D407-667-105
Job Sheet 164200

Part Name: Fwd Crosstube - High 407

DRAWING NO. D407-667-145	TITLE CROSSTUBE ASS'Y (407 HIGH FWD)	REV. C	DART AEROSPACE LTD ENGINEERING ORDER		D.E.O. NO. D407-667-145-C-1	SHEET NO. SHEET 1 OF 1	SCALE NTS
DRAWN <i>q</i>	CHECKED <i>ASS</i>	MFG. APPR. <i>18</i>	APPROVED <i>WD</i>		DE APPR. <i>##</i>		
DATE 11.07.15	DATE 11.07.22	DATE 11.07.22	DATE 11/07/22		DATE 11.07.21

DRAWING NO. D407-667-145	TITLE CROSSTUBE ASS'Y (407 HIGH FWD)	REV. C	DART AEROSPACE LTD ENGINEERING ORDER	D.E.O. NO. D407-667-145-C-2	SHEET NO. SHEET 1 OF 1	SCALE NTS
DRAWN AJS	CHECKED <i>[Signature]</i>	MFG. APPR. <i>[Signature]</i>	APPROVED <i>[Signature]</i>	DE APPR. <i>[Signature]</i>		
DATE 12.08.02	DATE 12.08.02	DATE 12.08.02	DATE 12.08.02	DATE 12.08.02	DATE 12.08.02

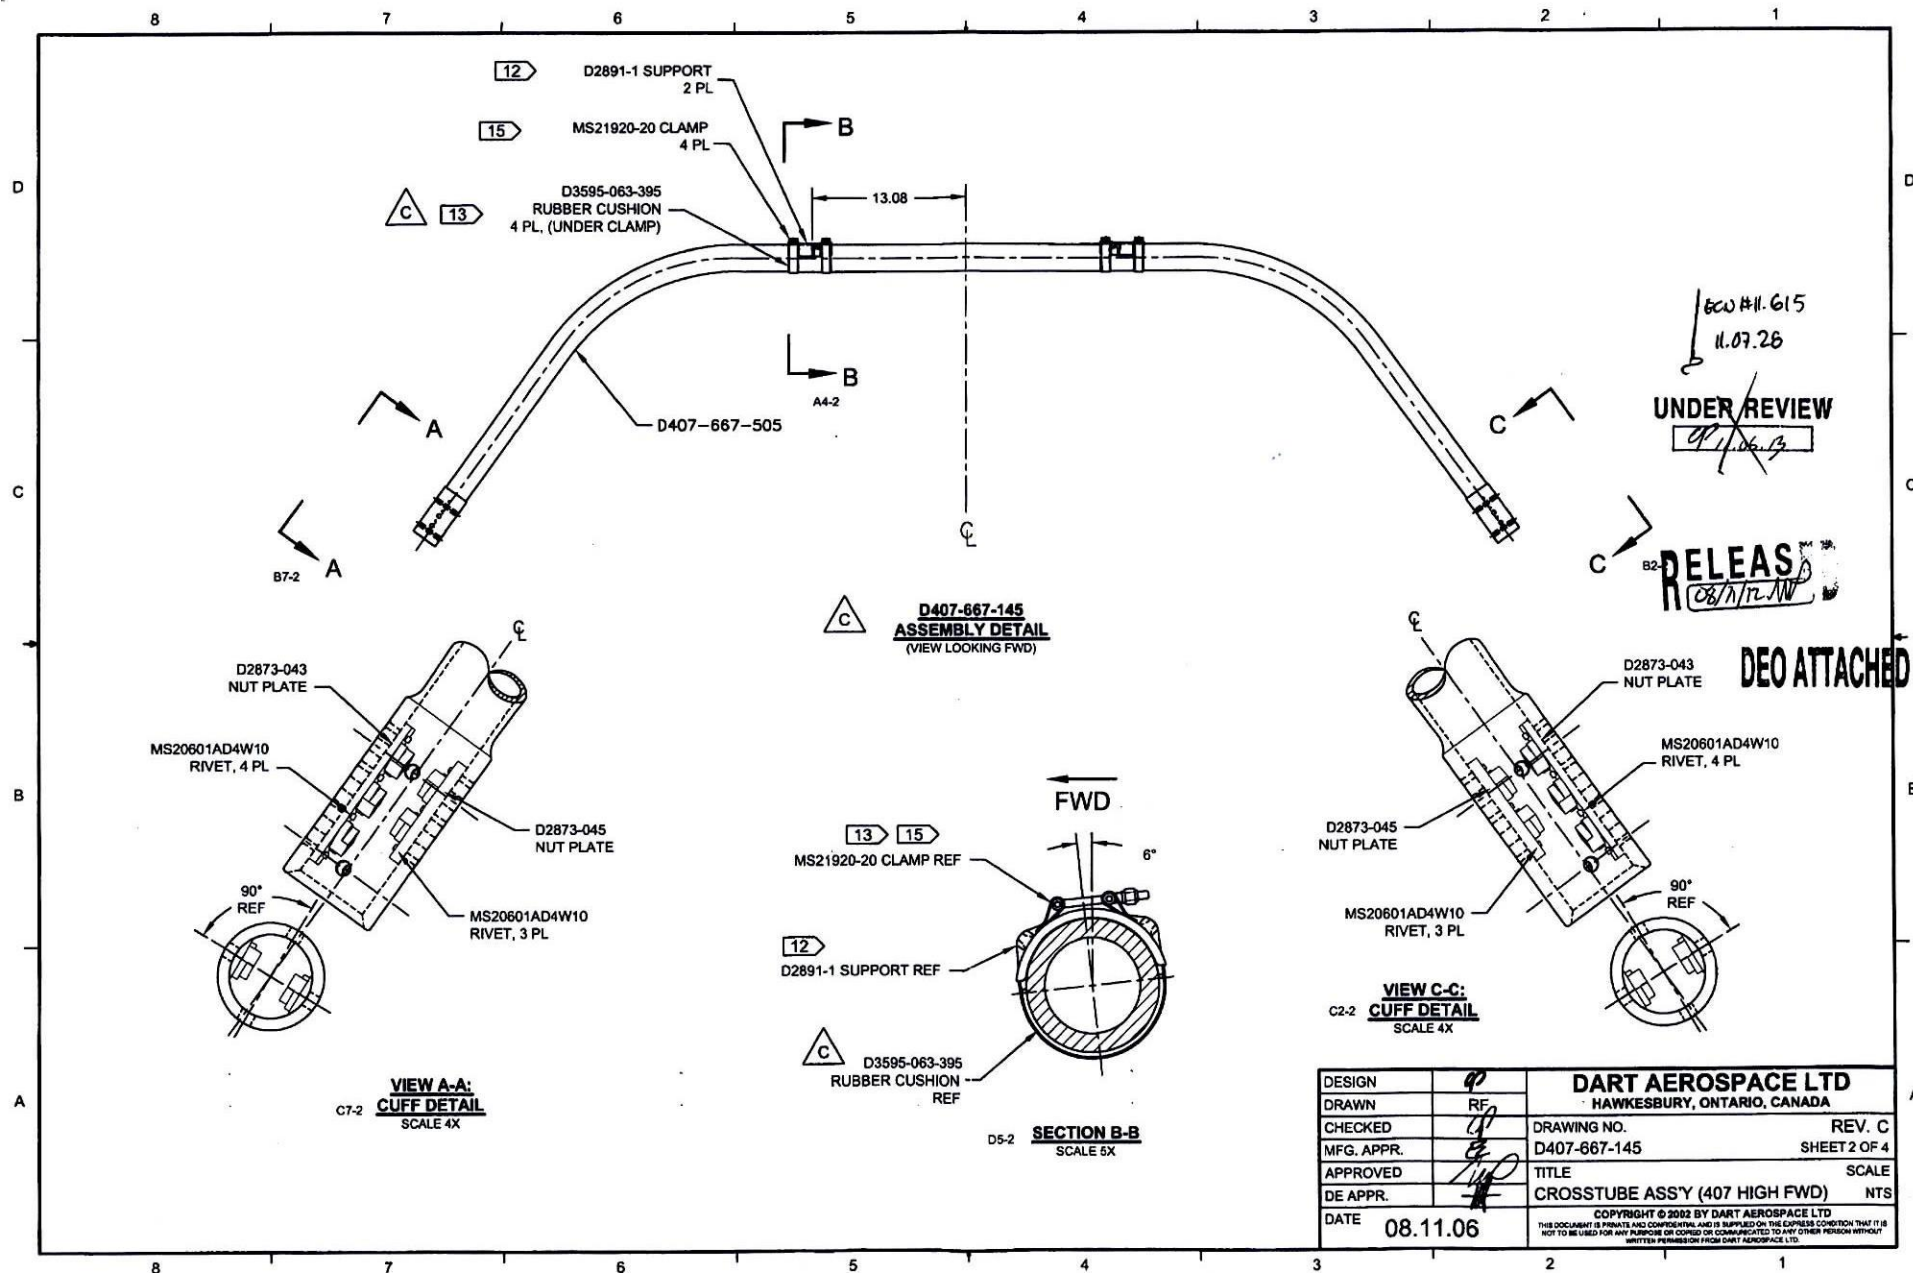
C	REVISE GENERAL NOTES/PART LIST (ZN D7-1); REORGANIZED VIEWS AND REFORMATTED DRAWING TO CURRENT STANDARDS. D3595-063-395 WAS D2856-400-694 (ZN D8-2 & A5-2); REMOVED REF. 7 ADD TOLERANCES (ZN C6-3, C4-3, D2-3); RELOCATED FLAG #6 (ZN A8-3) PER NCR 210; MOVED TURNING DETAIL & UPDATED TOLERANCE TO SHEET 4.	RF	08.11.06
B	ADD HOLES AND NUT PLATES FOR COMPATABILITY WITH BHT/AA SKUDTUBES	PH	05.07.26
A	NEW ISSUE	CP	02.05.08
REV.	DESCRIPTION	BY	DATE
DESIGN	RF	DART AEROSPACE LTD	
DRAWN	RF	HAWKESBURY, ONTARIO, CANADA	
CHECKED	RF	DRAWING NO.	REV. C
MFG. APPR.	RF	D407-667-145	SHEET 1 OF 4
APPROVED	RF	TITLE	SCALE
DE APPR.	RF	CROSSTUBE ASS'Y (407 HIGH FWD)	NTS
DATE	08.11.06	COPYRIGHT © 2002 BY DART AEROSPACE LTD THIS DOCUMENT IS PRIVATE AND CONFIDENTIAL AND IS SUPPLIED ON THE EXPRESS CONDITION THAT IT IS NOT TO BE USED FOR ANY PURPOSES OR COPIED OR COMMUNICATED TO ANY OTHER PERSON WITHOUT WRITTEN PERMISSION FROM DART AEROSPACE LTD.

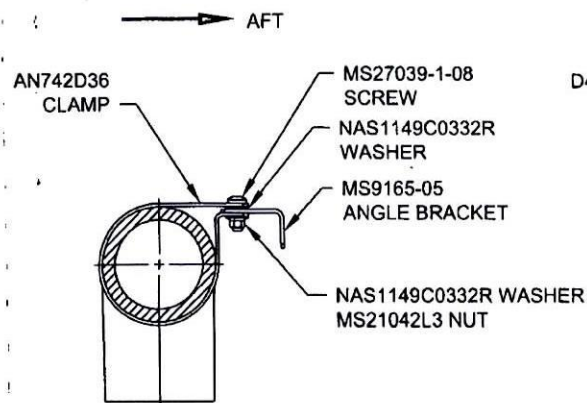
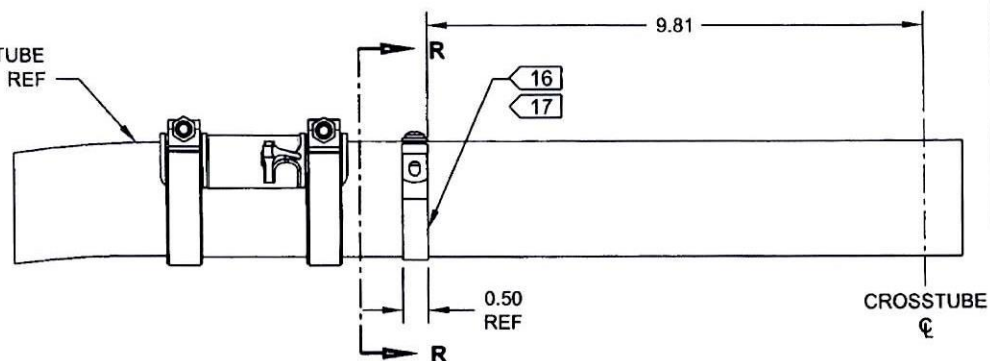
ADD ELECTRICAL GROUNDING STRAP

ADD

ADD

ITEM	QTY -145	PART NUMBER	DESCRIPTION
1	X	D407-667-145	CROSSTUBE ASSEMBLY (407 HIGH FWD)
10	2	AN742D36	CLAMP
11	2	MS9165-05	ANGLE BRACKET
12	2	MS21042L3	NUT (OR MS21042-3)
13	2	MS27039-1-08	SCREW
14	4	NAS1149C0332R	WASHER (OR AN960C10L)
